METRO PLANNING COMMITTEE
OF THE TOWN PLANNING BOARD

MPC Paper No. 19/11
For Consideration by the
Metro Planning Committee on 4.11.2011

FURTHER CONSIDERATION OF THE DRAFT PLANNING BRIEF FOR
"COMPREHENSIVE DEVELOPMENT AREA" SITE IN WONG CHUK HANG

圖 PLAN
 2

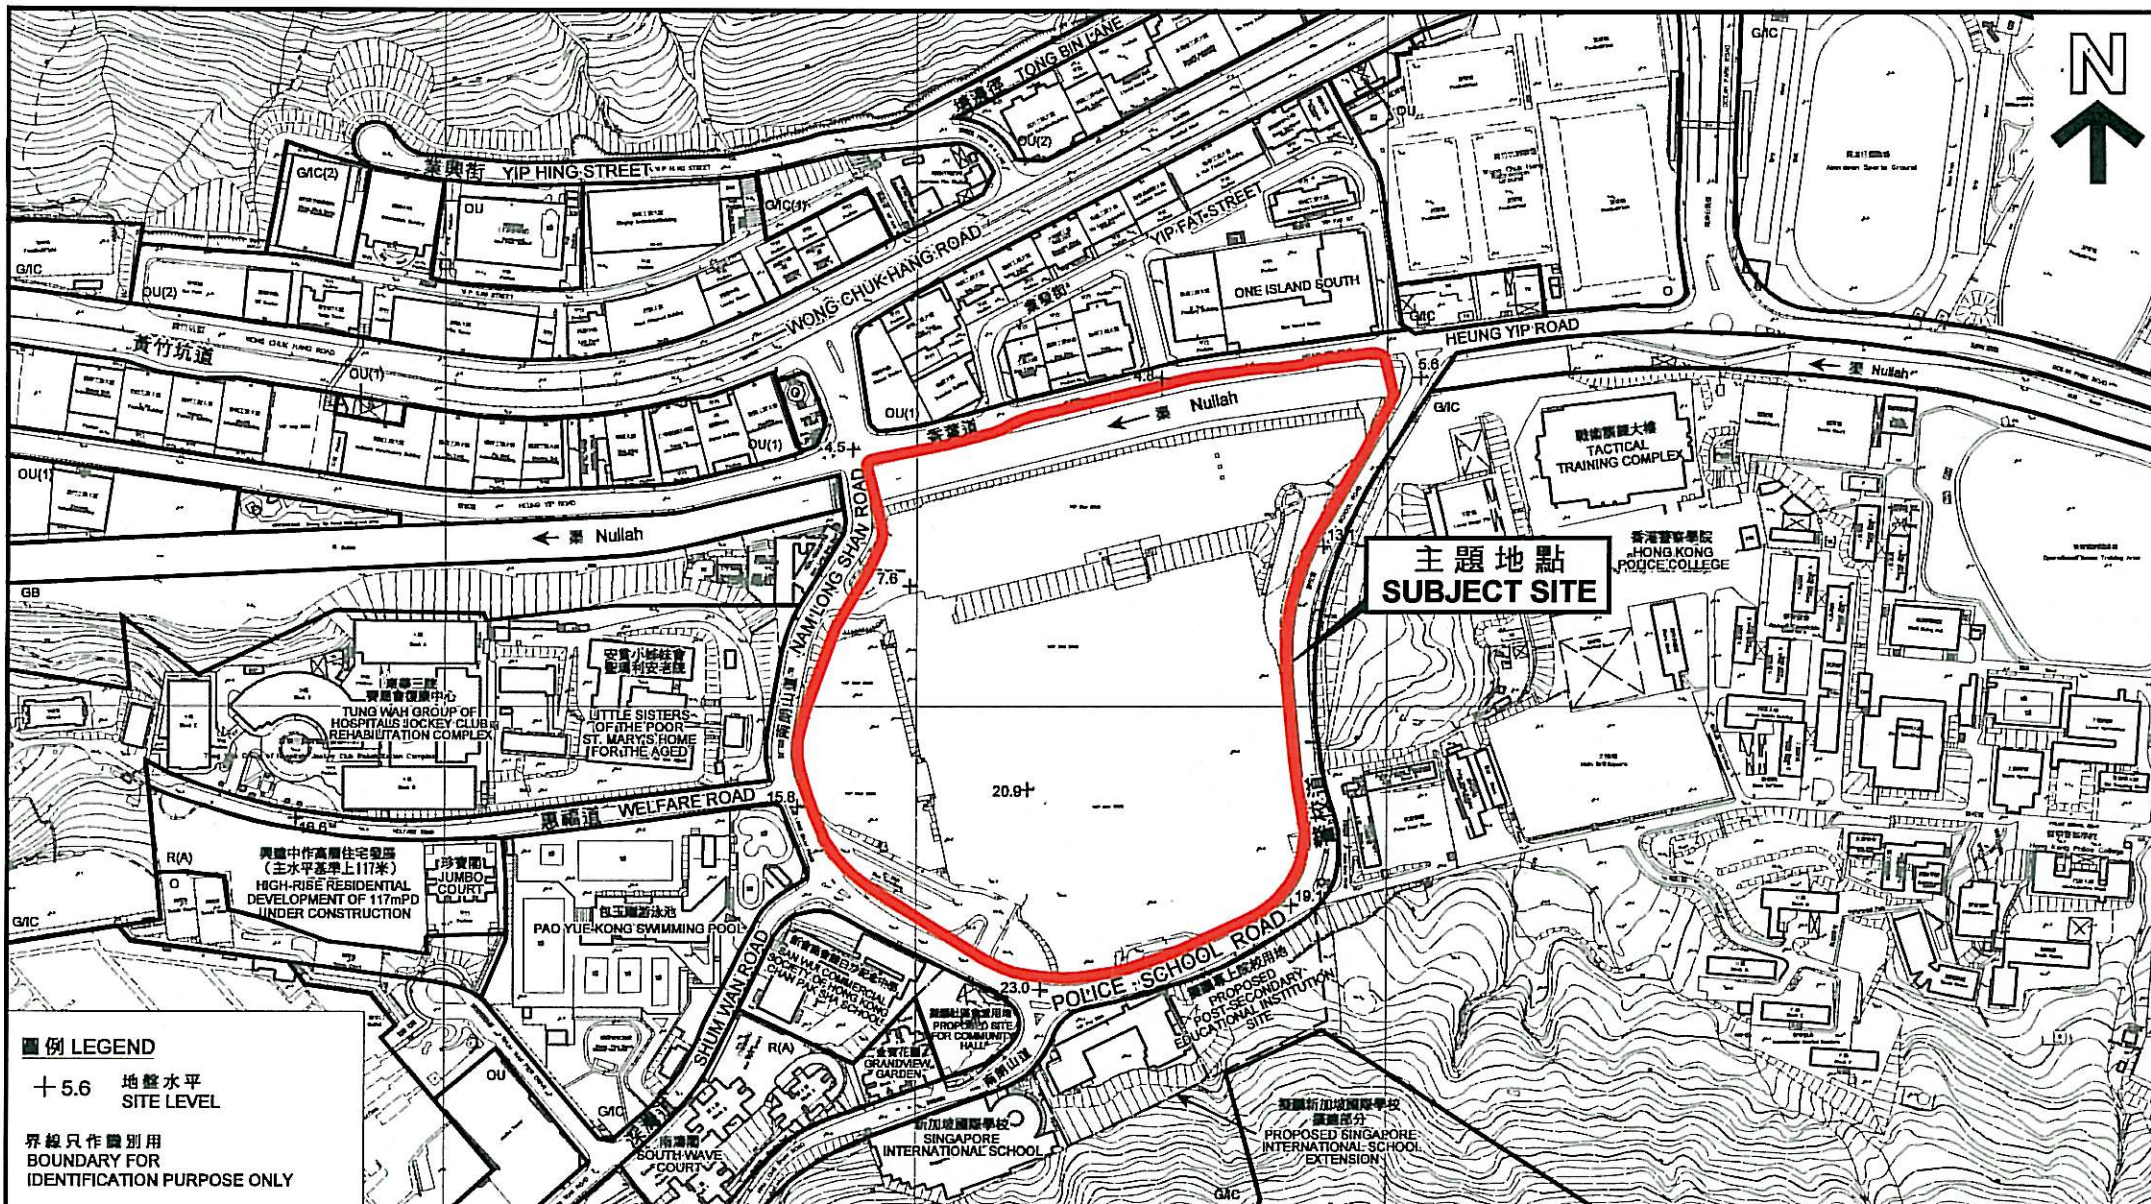
- (k) the temporary bus terminus site at Nam Long Shan Road should be developed for community hall;

- 4.16 The temporary bus terminus site at Nam Long Shan Road, which is currently occupied by MTRCL as a works area, has already been reserved for the development of a community hall (**Plan 2 of Attachment I**). The Home Affairs Department will review the development programme of the community hall having regard to the timing of return of the site upon completion of SIL(E).
